PLANNING COMMISSION AGENDA

**PLANNING COMMISSION
STAFF REPORT – October 19, 2016 MEETING
CASE NUMBER: RZ-16-0377
Case Manager: Frank G. Breaux, AICP**

**PLANNING COMMISSION
 STAFF REPORT – October 19, 2016 MEETING
 CASE NUMBER: S-16-0386
 Case Manager: Frank G. Breaux, AICP**

**PLANNING COMMISSION
STAFF REPORT – October 19, 2016 MEETING
CASE NUMBER: RZ-16-0387
Case Manager: Frank G. Breaux, AICP**

CRUSHED AGGREGATE SECTION

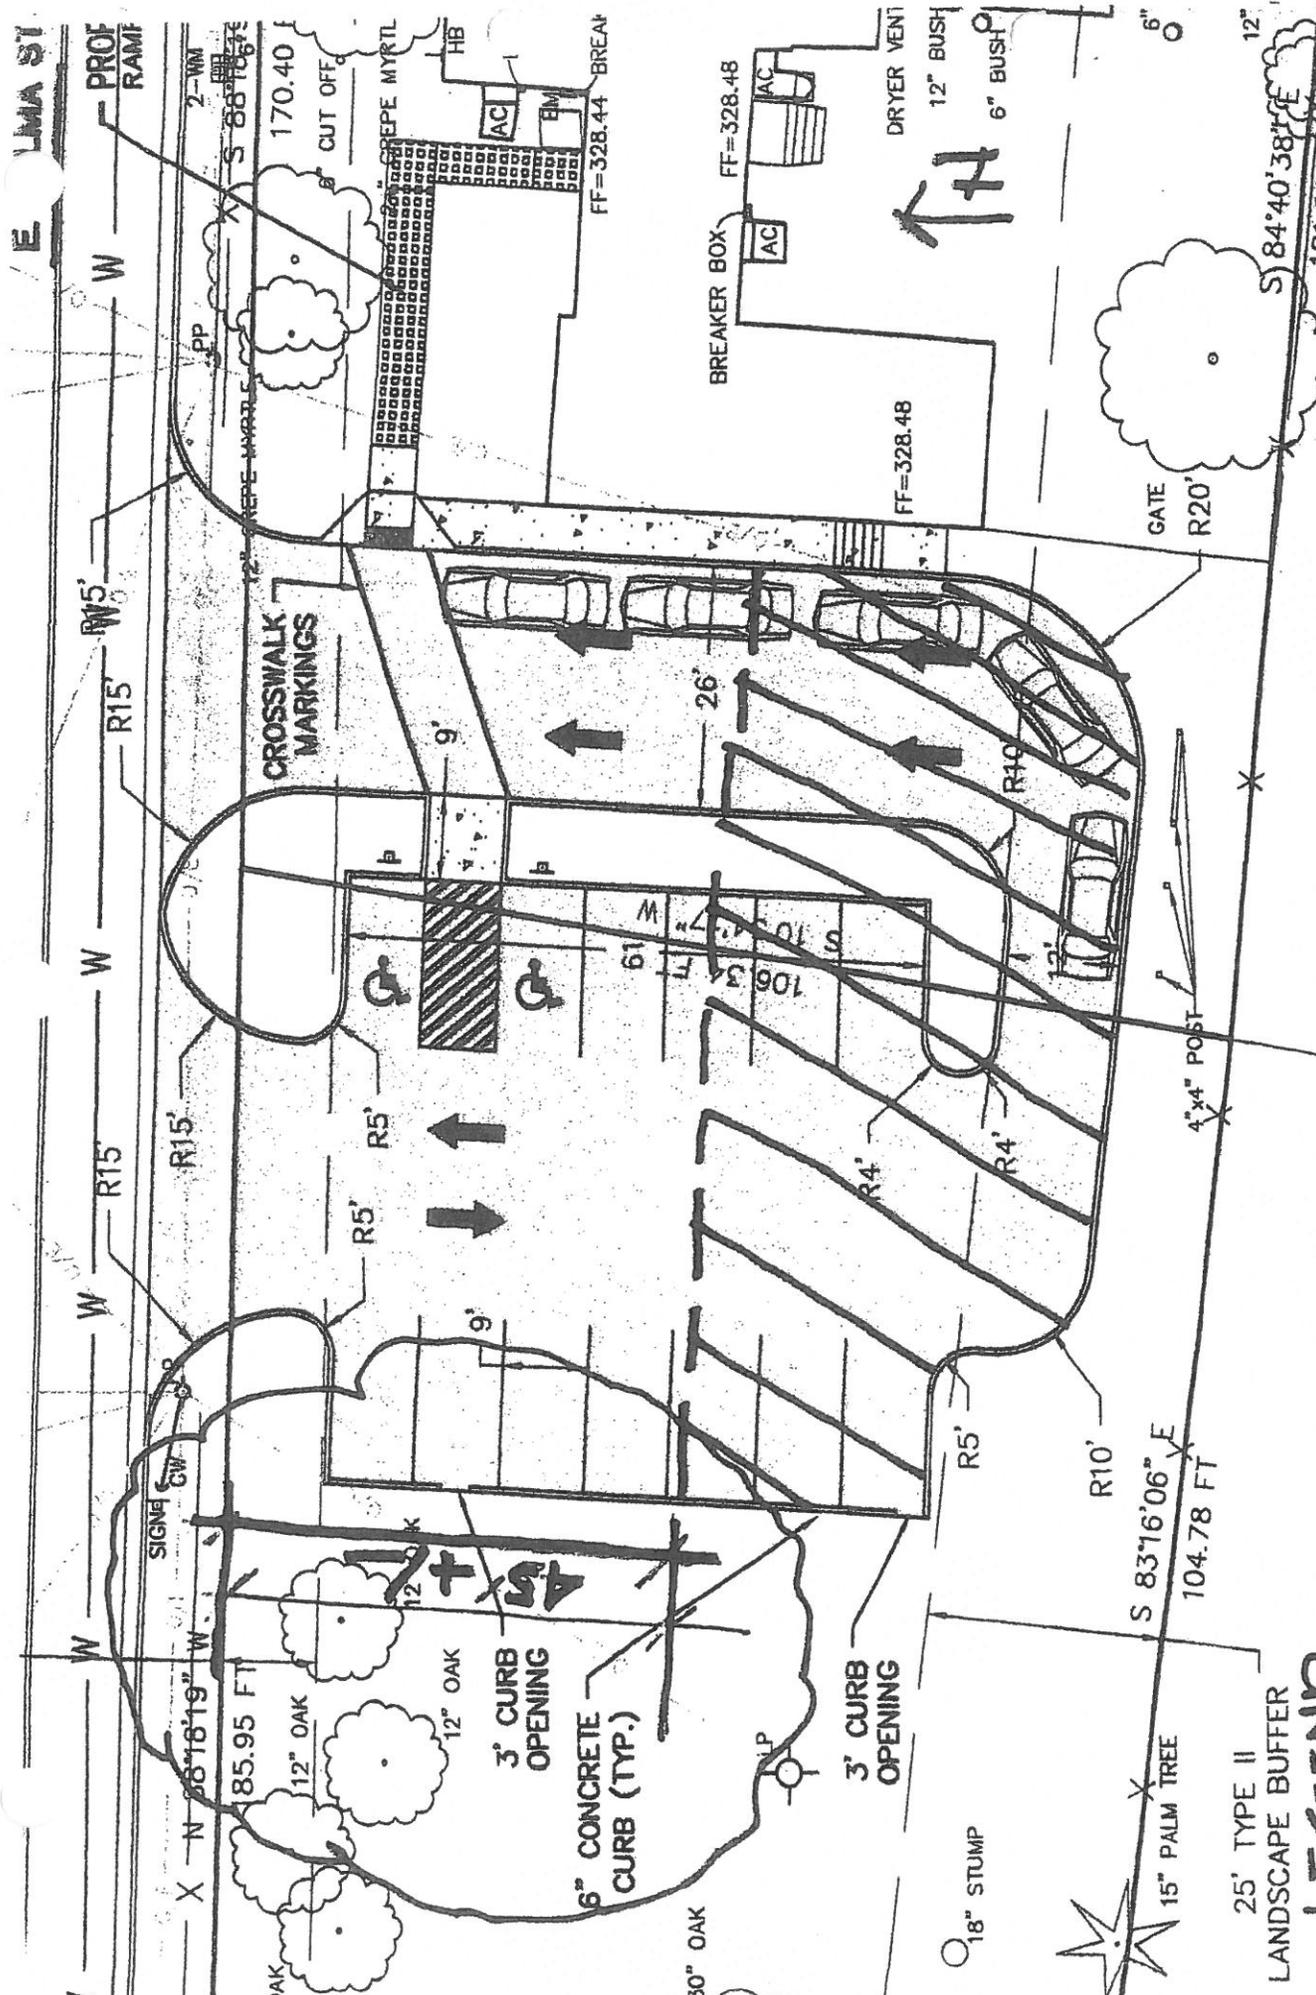
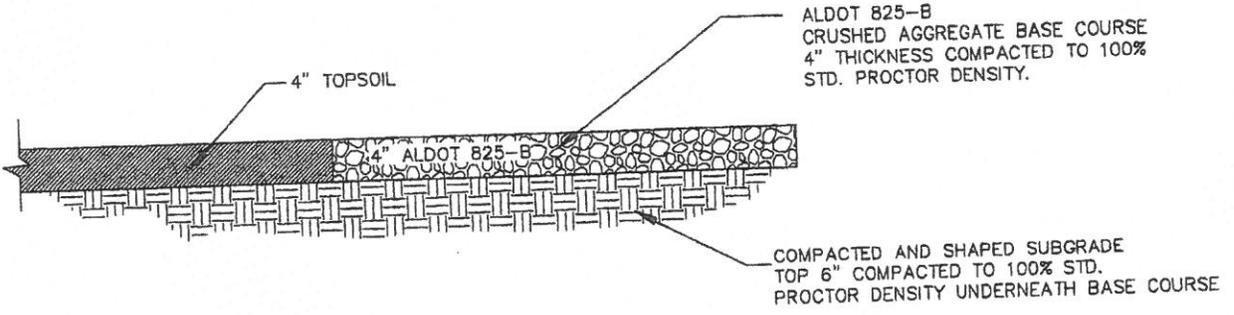
The Alternative parking surface will begin 45' +/- from the Selma Street Property Line. This will enable the owner to provide the approved 2 handicap accessible parking spaces and five spaces on the approved parking surface.

The alternative parking surface will provide parking for the remaining six vehicles. The total number of parking spaces will remain a total of 13 parking lanes as approved by the Planning Commission.

Once again please find attached drawing for alternative parking surface and construction detail for the alternative parking surface. **Please see Crushed Aggregate Section. (ALDOT 825-B)**

If the Planning Commission elects to approve the request, the transition area of the parking lot should be designed so that adjacent parking spaces are wholly of one material or another and that the edge of the pavement portion is protected from deterioration with a flat ribbon curb or other method acceptable to the Public Works director.

PLAT

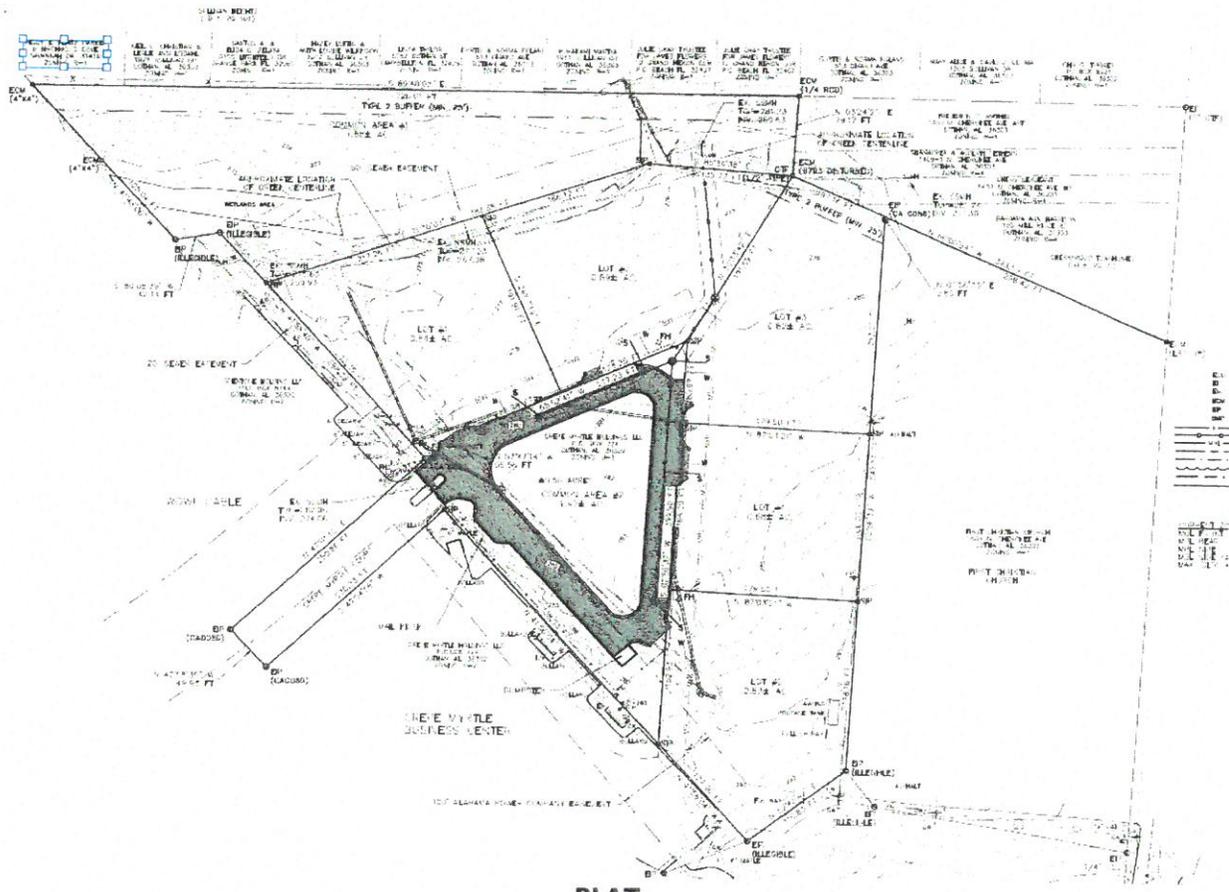
1. We will require storm drainage calculations as submitted to support a storm drainage plan for review and approval for this subdivision. The post-development peak discharge rate shall be limited to the pre-development peak discharge rate for the 2-, 10-, and 25-year storm events unless site conditions dictate differently. There is no detention facility shown.

2. The designs for all utilities are to be submitted in the complete set of construction plans, including electric, gas, cable TV, and telephone. Locations of junction boxes and conduits should be shown. **A pre-design meeting shall be set up by the developer or design engineer with all applicable utility representatives and the City of Dothan.** The owner/developer is responsible for relocating any utility facilities (water services, fire hydrants, street lights, utility poles, telephone boxes, etc.) that may interfere or require relocating due to this development. Fire hydrants shall be located per the fire code as required by the fire marshal.

3. Provide a copy of the ADEM NPDES permit for this project. Provide a note on the construction plans stating that all erosion control measures shall be in place as required by the engineer, plans, and City of Dothan representative. An inspection log will be required to be submitted to the City of Dothan. Siltation control measures shall be inspected as required by permit. Any deficiencies shall be corrected immediately and no further work will proceed until said deficiencies are corrected to the City of Dothan or engineer's approval. The designer or contractor must submit a site plan depicting the placement and scheduling of erosion and/or sedimentation control prior to the commencement of work on this project.

4. Provide the deed book and page number for all existing easements. The wetlands area and ditch from the North side shall be in a private drainage easement.

5. All sanitary sewer laterals shall be designed to be located 10 feet on the downstream side of sewer flow from the water meter which shall be designed to be at the center of the lot. The sanitary sewer laterals shall be a minimum of 60 inches below finished grade if existing elevations allow. Any laterals less than 48 inches below finished grade shall be ductile iron.

6. Private drainage easements shall be provided for the preliminary storm system layout for this development. Part of the roadway and storm drain are on private lots. They shall be within an ingress/egress private utility and drainage easement or similar.

7. The sanitary sewer shall be in a private sanitary sewer easement. The roadway shall be labeled private drive ingress/egress private utility and drainage easement.

8. Sanitary Sewer flow calculations shall be submitted to Engineering Services as soon as possible. The subdivision may be approved if sanitary sewer flows acceptable.

9. Concrete monuments are required at all bearing changes along the boundary of this development unless an existing iron pin or other marker is present. Concrete monuments will be required where the road ROW connects with the boundary. Monuments are also required at all curvature points and bearing changes along the road ROW.

10. Provide a north arrow on the vicinity map.
11. Verify that the existing easements shown are called out as labeled. Also provide deed book and page where they are recorded.

12. The existing ditch along the north side of lots 1-3 may require some type of improvements as part of this subdivision or it shall be removed from the lots and put into a common area and "shall not disturb drainage easement" shown in this area.
13. Lot 1, 2 & 3 shall have a minimum finish floor of 1 foot above the upstream sanitary sewer manhole or tie-in manhole.
14. Dumpster pad shouldn't be in roadway there by blocking traffic when being serviced. Extend the turnout for the dumpster pad.

1. Preliminary Plat approval is valid for 12 months from the date of approval and construction plans must be submitted within 12 months unless a one-time extension has been granted by the Planning Commission;
2. Per Section 90-141(f), sidewalks shall be required as approved on the development plan(s);
3. The comments of all city departments are satisfied and/or incorporated into the Construction Plans and Final Plat; and,
4. All future correspondence and submittals shall reference Case S-16-0386.

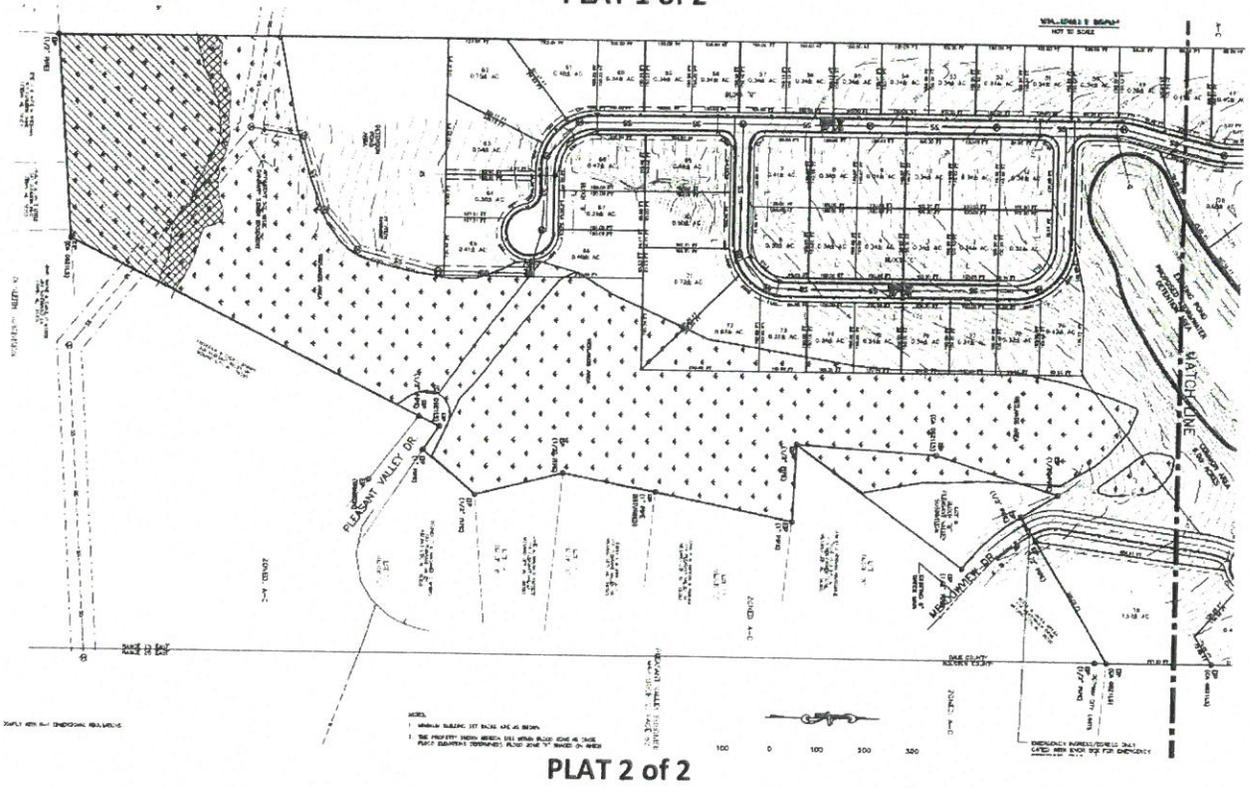
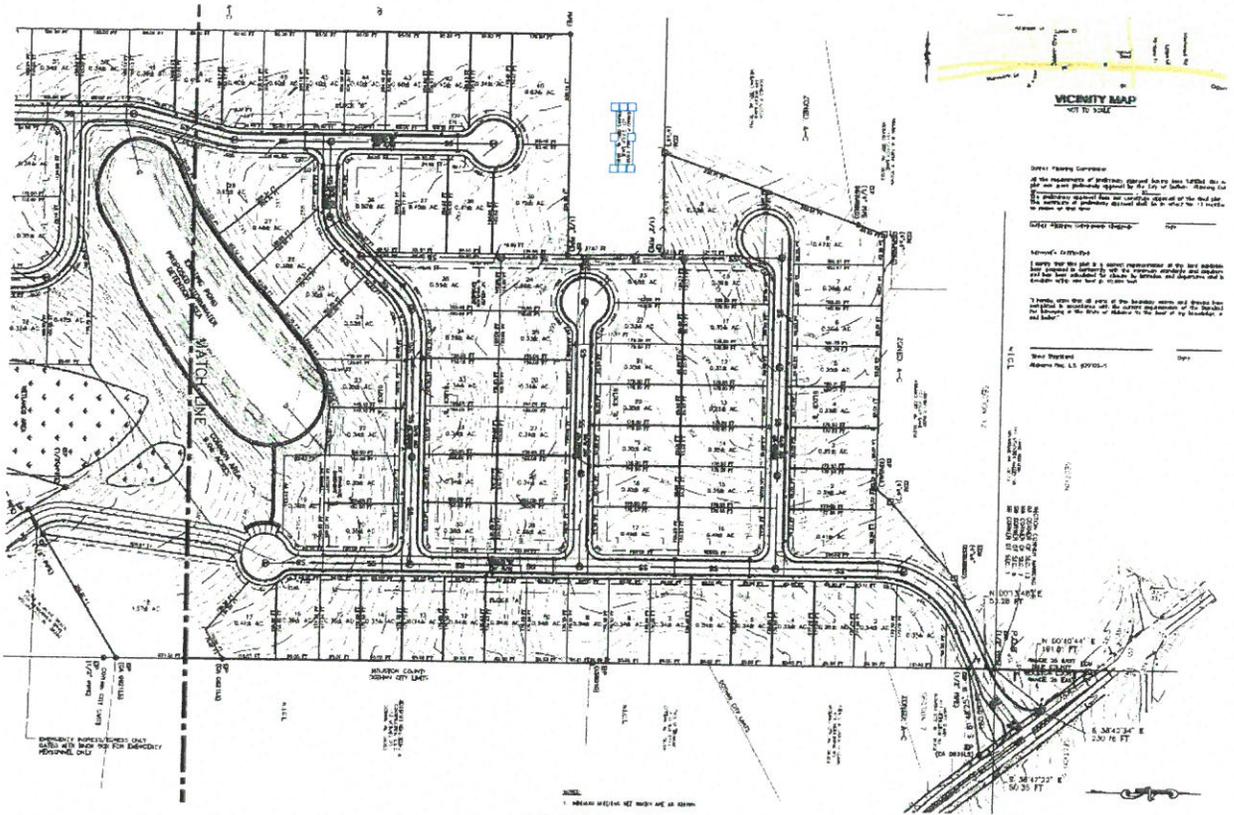
- 1) We will require storm drainage calculations as submitted to support a storm drainage plan for review and approval for this subdivision. The post-development peak discharge rate shall be limited to the pre-development peak discharge rate for the 2-, 10-, and 25-year storm events unless site conditions dictate differently.
- 2) The designs for all utilities are to be submitted in the complete set of construction plans, including electric, gas, cable TV, and telephone. Locations of junction boxes and conduits should be shown. **A pre-design meeting shall be set up by the developer or design engineer with all applicable utility representatives and the City of Dothan.** The owner/developer is responsible for relocating any utility facilities (water services, fire hydrants, street lights, utility poles, telephone boxes, etc.) that may interfere or require

- relocating due to this development. Fire hydrants shall be located per the fire code as required by the fire marshal.
- 3) Provide a copy of the ADEM NPDES permit for this project. Provide a note on the construction plans stating that all erosion control measures shall be in place as required by the engineer, plans, and City of Dothan representative. An inspection log will be required to be submitted to the City of Dothan. Siltation control measures shall be inspected as required by permit. Any deficiencies shall be corrected immediately and no further work will proceed until said deficiencies are corrected to the City of Dothan or engineer's approval. The designer or contractor must submit a site plan depicting the placement and scheduling of erosion and/or sedimentation control prior to the commencement of work on this project.

- 4) The Minimum Finish Floor (MFF) for each lot shall be a minimum of one foot above the upstream SS manhole and shall be labeled on the final plat for each lot it applies to. A note shall also be provided stating that a backflow preventer may be installed on each lot in lieu of the MFF requirement. This must be shown or noted for all lots where applicable.

- 5) Show and label the existing easements adjacent to this development. Provide the deed book and page number for all existing easements.
 - 6) All sanitary sewer laterals shall be designed to be located 10 feet on the downstream side of sewer flow from the water meter which shall be designed to be at the center of the lot. The sanitary sewer laterals shall be a minimum of 60 inches below finished grade if existing elevations allow. Any laterals less than 48 inches below finished grade shall be ductile iron.

- 7) Any sanitary sewer mains that are running parallel and are under or near the curb line shall be moved closer to the center of the road. Provide eight (8) to ten (10) feet between the sanitary sewer line and the water line at all locations where they are parallel each other. Sanitary sewer shall be moved to at least 10 feet away from storm inlets and storm drain where possible.

- 8) Sanitary Sewer design flow calculations shall be submitted to Engineering Services.
 - 9) A ten (10) foot U&D easement on the front of each lot shall be shown and labeled.

- 10) Any easements associated with utilities and drainage should be shown and labeled on the plat.
 - 11) All areas that are not lots shall be labeled as common area.

- 12) The ROW at the entrance drive shall have a 20 foot minimum radius.
 - 13) Label the drive coming off Meadowview Drive as emergency entrance and exit only. Label as "Private Drive Emergency Ingress/Egress".

- 14) The retention area and wetlands area shall be private drainage easements. The detention area shall be a drainage easement. A note shall be provided on the plat as to who will maintain it. As well as the note about the city is only responsible for maintaining the structures.

- 15) Provide sanitary sewer stub and easement to adjacent property at locations where it will work. Contact this office to discuss possible locations. Also continue the sanitary sewer main to Bethlehem Road and stub out to the ROW on the north side of the entrance drive for future access.

- 16) In the legend specify that the hatched flood zone x is the (0.2 %) 500 year special flood hazard area.
- 17) The parking spaces in the cul-de-sac of Road "A" shall not be on the ROW; the city will not maintain this area.
- 18) The wetlands area on any lots need to be within a "Do Not Disturb" area or preferably taken out of each lot.
- 19) Is lot 8 of Pleasant Valley subdivision going to be replatted? If not, remove from boundary or label not included.
- 20) Label Bethlehem Road and show the ROW width.
- 21) Road "A" and "D" shall have a 220 #/sy asphalt surface course.
- 22) Provide a private drainage easement and swale along the rear of Lots 10-23, Block "B" to tie into the drainage system.
- 23) A two year maintenance warranty and bond is required for this development.

1. The plans show the water main tap and supply line for the subdivision on the North side of the proposed entrance drive off Bethlehem Road and then crossing over the drive once inside the development. The water main tap off Bethlehem Road shall be installed on the South side of the proposed entrance drive and eliminate the need for the water main to cross over.
2. Install a fire hydrant assembly at the entrance drive in the small area before lot #1.
3. Relocate the fire hydrant assembly from Block A property line 6/7 to Block A property line 5/6.
4. Install main size tee with (3)-three main size gate valves at the intersection of Road A and Road D.
5. Install a new main size gate valve at the connection point at Meadowview Drive.

1. Install main size tee and gate valve at intersection of Road A and Road B.
2. Relocate the fire hydrant assembly at Block B property line 4/5 to Block B property line 5/6.
3. Install a main size x 3" reducer and 3" gate valve after the fire hydrant.
4. Continue the proposed 3" water main from lot 8 around the cul-de-sac to the sanitary sewer easement on lot 9 and install the required flush assembly.

1. Install main size tee and gate valve at intersection of Road A and Road C.
2. Install the required flush assembly at Block B property line lot 24/25.

1. Preliminary Plat approval is valid for 12 months from the date of approval and construction plans must be submitted within 12 months unless a one-time extension has been granted by the Planning Commission;
2. A second "emergency only" access point is provided at the terminus of Pleasant Valley Drive;
3. The comments of all city departments are satisfied and/or incorporated into the Construction Plans and Final Plat; and,
4. All future correspondence and submittals shall reference Case S-16-0387.
